Master Power Relay Cover

M20C, 2742, 2807 - 2999; M20D, 252 - 258

FIGURE 1

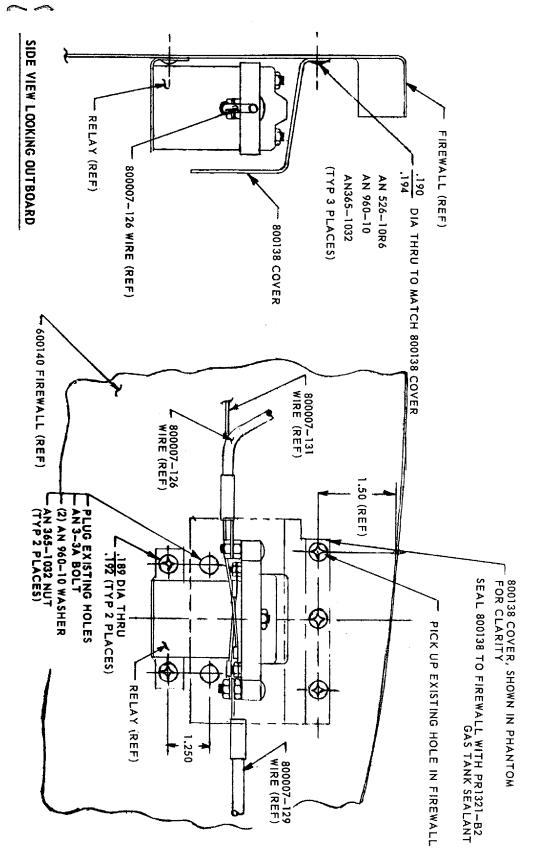
- 1. Remove the top engine cowling.
- 2. Disconnect battery positive cable from battery post.
- 3. Remove all wires from relay, noting their location.
- 4. Remove relay from firewall.
- 5. Rotate the power relay 180° (see Figure 1).
- 6. Install relay on firewall with hardware previously removed in its new location (ref. Figure 1).
- 7. Install 800138 cover as shown in Figure 1 sealing between the cover and the firewall with a coat of PR1321-B2 gas tank sealant.
- 8. Install the wires as shown in Figure 1.
- 9. Reconnect battery positive lead to battery post.
- 10. Install the top engine cowl previously removed.
